# SAN FRANCISCO PLANNING DEPARTMENT

## Supplemental Service Variants for the Transit Effectiveness Project EIR Memorandum to the San Francisco Planning Commission

*Date:* March 13, 2014  
*Case No.:* **2011.0558E**  
*Project Title:* **Transit Effectiveness Project (TEP)**  
*Zoning:* Citywide – N/A  
*Block/Lot:* Citywide – N/A  
*Lot Size:* Citywide – N/A  
*Project Sponsor:* San Francisco Municipal Transit Agency (SFMTA)  
Sean Kennedy, Program Manager, TEP  
*Lead Agency:* San Francisco Planning Department  
*Staff Contact:* Debra Dwyer – (415) 575-9031  
Debra.Dwyer@sfgov.org

## Line 35 - Eureka (Revised) Recommended Route Alignment

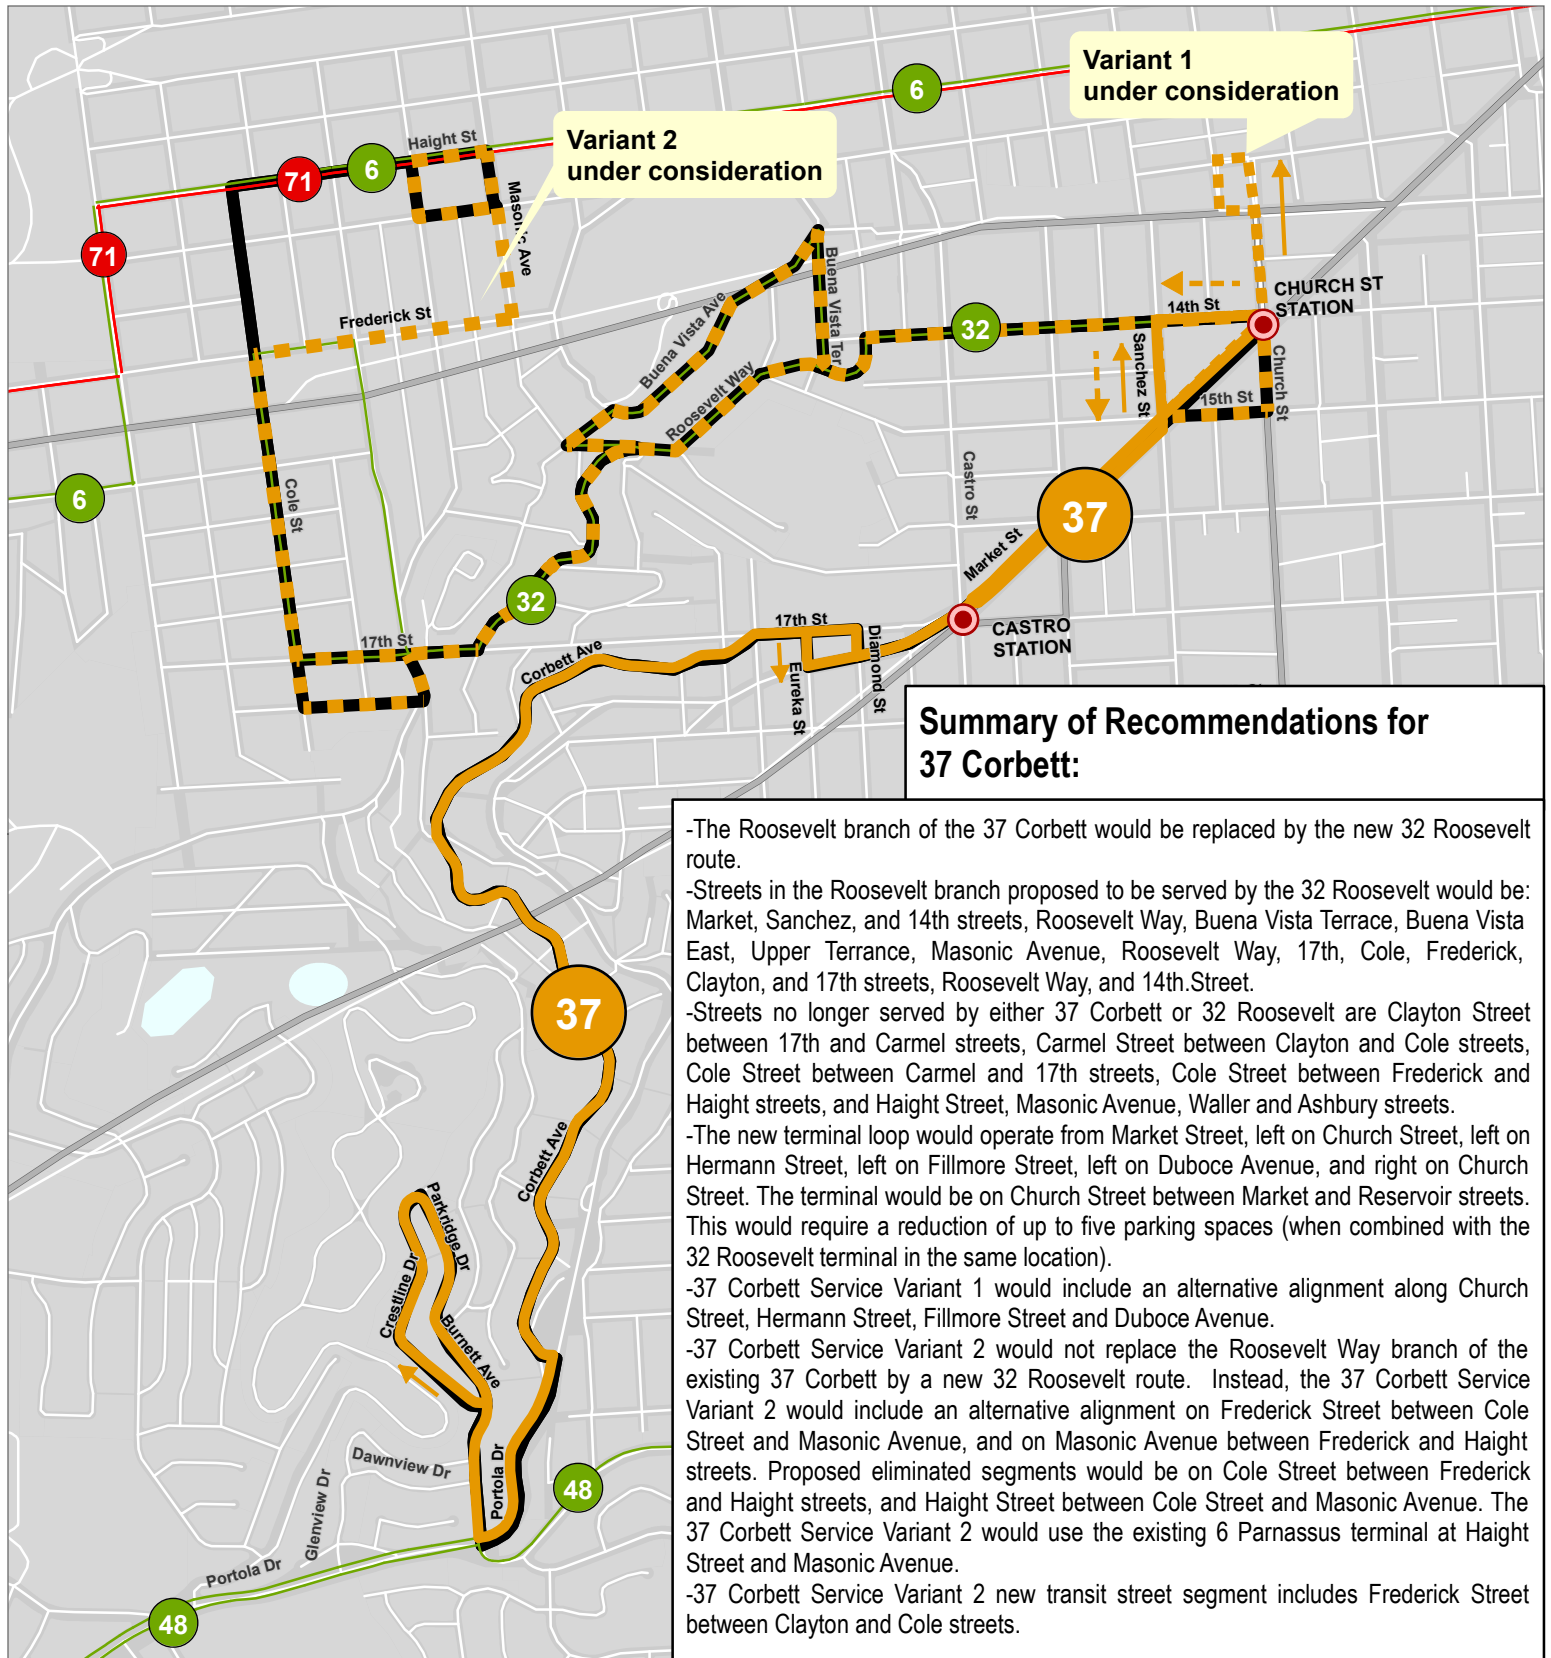
The 35 Eureka Supplemental Service Variant 2 new transit street segments not currently served by any Muni route would be Bemis Street between Addison and Miguel streets, Miguel Street between Bemis and Arlington streets, and Arlington Street between Miguel and Bosworth streets. Please see the Service Variant shown on the revised 35 Eureka Service Improvement map.

The 35 Eureka Service Variant 3 new transit street segments not currently served by any Muni route would be Bemis Street between Addison and Miguel streets, and Miguel Street between Bemis and Chenery streets. Please see the Service Variant shown on the revised 35 Eureka Service Improvement map.

- Variant 3 would include an alternative routing to Variant 2 in which two-way service would be provided on Chenery Street. This would replace the one-way transit service that is proposed going westbound on Arlington and eastbound Chenery Street that is proposed under Variant 2.

## Line 37 - Corbett (Revised) Recommended Route Alignment

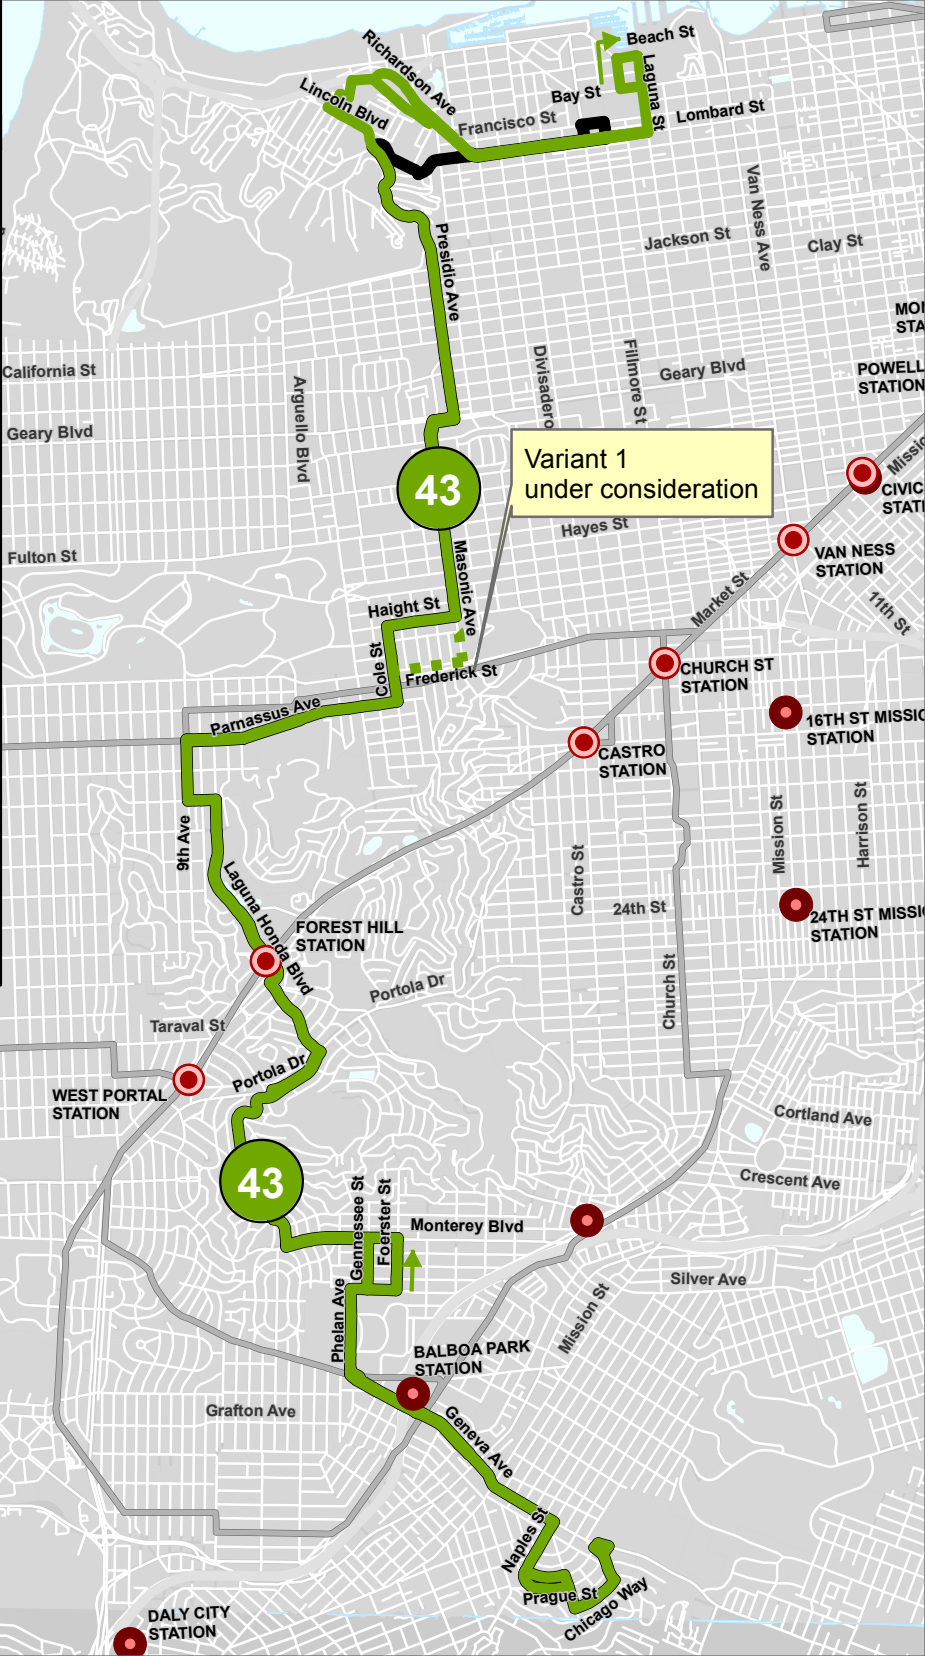
The 37 Corbett Supplemental Service Variant 2 new transit street segment not currently served by any Muni route would be Frederick Street between Clayton and Cole streets. Please see the Service Variant shown on the revised 37 Corbett Service Improvement map.
